AGENDA
Design Review Committee
March 12, 2025 – REGULAR MEETING

Meeting Date:	March 12, 2024	Meeting Title:	Regular Design Review Committee Meeting
Applicant:	Teton County Hospital District	Presenter:	Andrew Bowen
Agenda Item:	(P24-180) 460 E Broadway Ave. The Hitching Post Apartments	Public Comment:

Meeting Date:	March 12, 2025	Item Number:	P24-199
Applicant:	Mogul Hospitality Partners – Jackson, LLC	Address:	325, 335, 345, 355, & 375 N. Cache Street, 45 & 65 Merfill Avenue, & 330, 350, 360, & 370 N. Glenwood Street
Recommendations:	Final Conceptual Review (Sketch Plan)

Meeting Date:	March 12, 2024	Meeting Title:	Regular Design Review Committee Meeting
Applicant:	Farmer Payne Architects	Presenter:	Andrew Bowen
Agenda Item:	(P25-37) 55 West Karns Avenue, 4-plex (Townhome Style Units)	Public Comment:

Design Change Analysis.

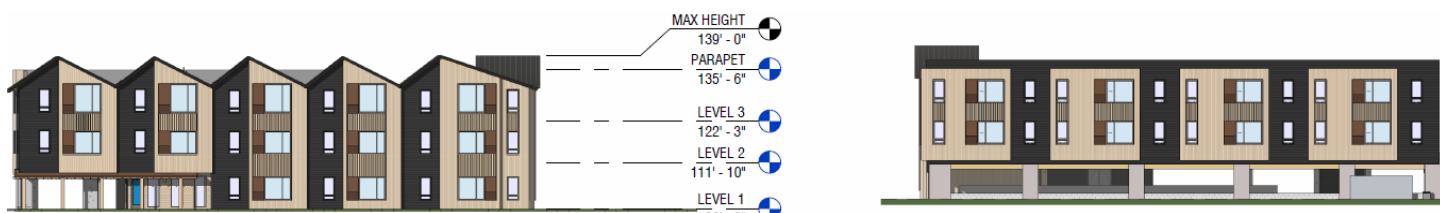
In general, the DRC was supportive of the proposed design in terms of overall site design, landscaping, courtyards, engaging entrances, and general livability of floor plans. Upon review, the DRC specifically appreciated the overall choice and quality of materials and expressed hope that material quality does not diminish as the project progresses.

The applicant notes that the eastern façade incorporates larger cutouts and a more dynamic floor plan on each level, creating a distinct rhythm and material application compared to the other elevations.

This request includes a complete set of revised architectural, engineering, and landscape plans (attached), updated since the conceptual review to address comments from the Design Review Committee.

BUILDING B

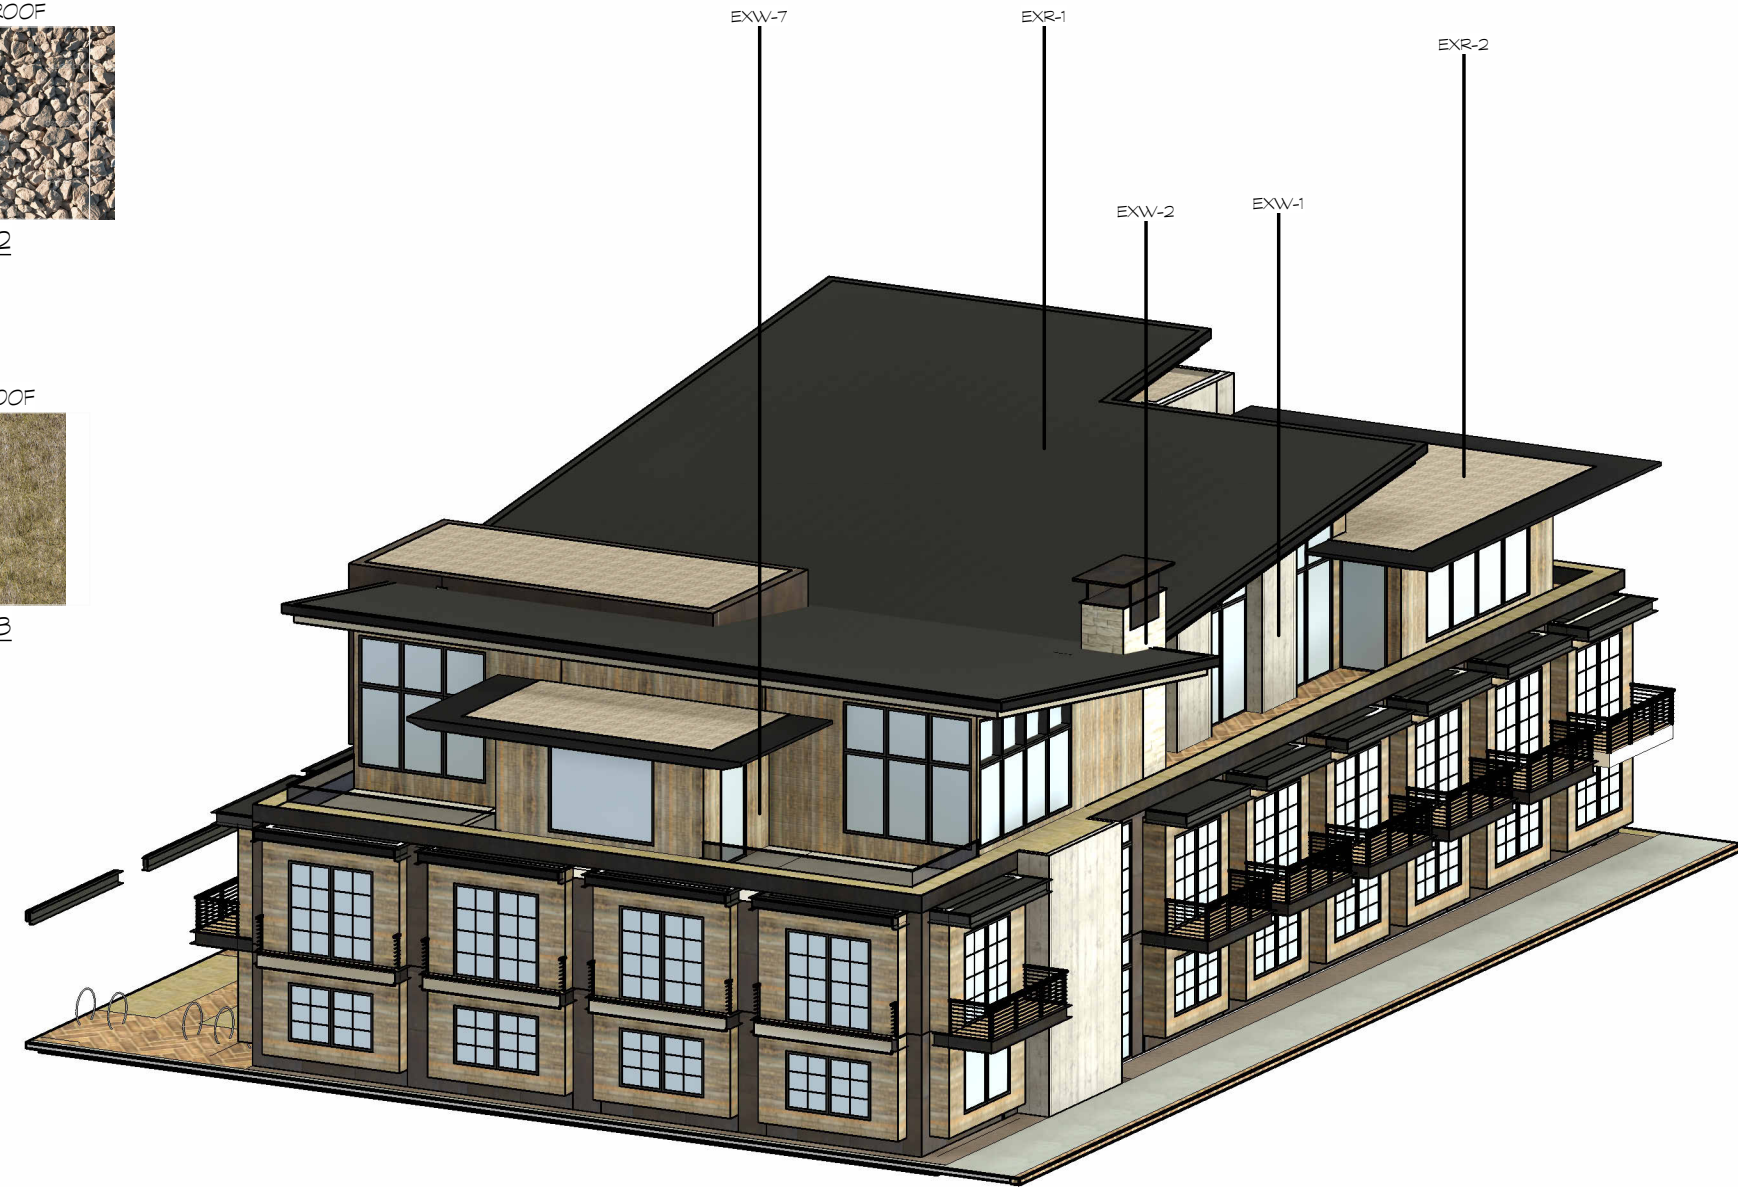
DRC Comment 1:

- The applicant needs to further study the architectural style of each building and modify the overall design and application of materials to improve the cohesiveness of the overall project. The DRC also felt that the application of materials and design elements still felt chaotic along North Cache and that the applicant needed to simplify the design along this frontage.
 - Applicant response to DRC Comment 1:
 - The Applicant modified the architectural style of the buildings along North Cache to create a more cohesive project, by combining similarities in architectural features and material selections. While the updated plan set provides a cohesiveness amongst buildings, the buildings also maintain unique architectural features that provide the massing breaks that the Town desires.

DRC Comment 2:

- Applicant response to DRC Comment 2:
 - Building C has been completely redesigned to fit the same architectural theme of Buildings B, D, and E along North Cache. The building is reprogrammed using reclaimed wood, board form concrete, and materials that are in common with Buildings D, E, and A along North Cache. In addition, the shape and structure of the building has been adjusted substantially to remove the modern “cubeness” that was referred to in the meeting. The reprogramming and redesign was inspired by several local projects, including the Cloudveil and the Hotel Jackson, displaying the building’s fit within the Jackson vernacular and softening the ‘heroic’ nature of Building C which is most prominent when approaching the Town from the North.
